COMMITTEE OF ADJUSTMENT

MINOR VARIANCE REPORT

APPLICATION: CAV A/109/2022

CAV A/109/2022 - 1118 Lakeshore Rd E (East District) (OP Designation: Low Density Residential - Special Policy)

Excerpt of site plan prepared by applicant with pave stone area highlighted:

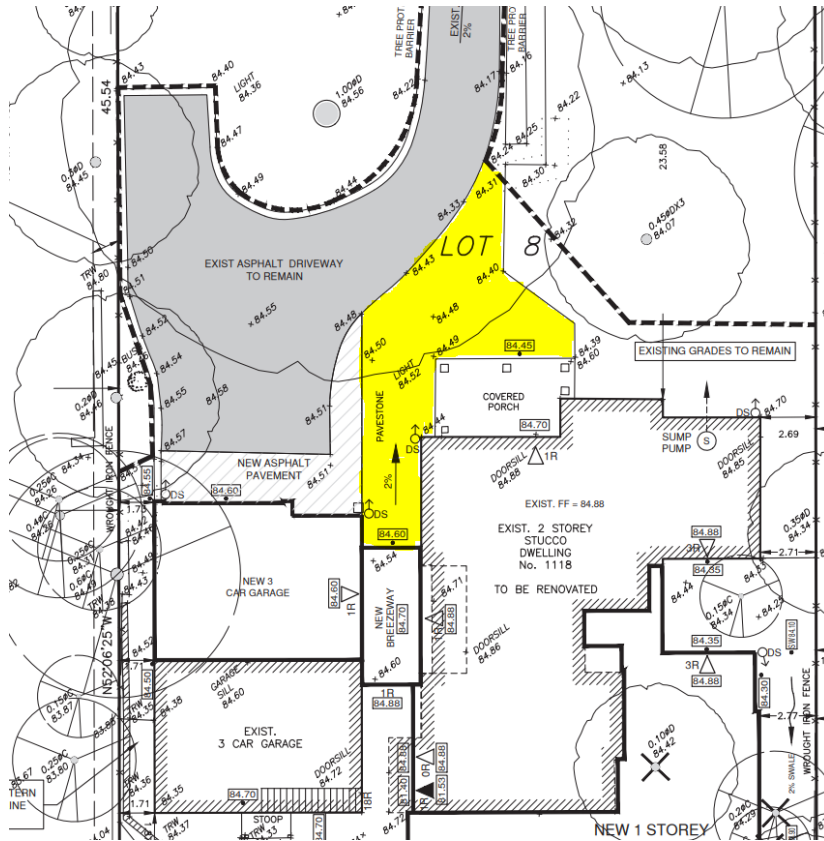
Notwithstanding the comments above, it appears that pave stone is proposed adjacent to the proposed driveway and wraps around the front porch which would be considered an extension of the driveway as highlighted in the excerpt of the site plan below. This would result in a greater driveway width than requested. Therefore, depending on the outcome of this application, the applicant may need to revise the proposal to comply with the driveway width regulation during construction, which may or may not be in general accordance with the plans submitted with this application. Alternatively, the applicant may request a deferral of this application in order to submit a Building Permit application for a complete Zoning review. It should be noted staff do not complete a full Zoning review of minor variance applications.
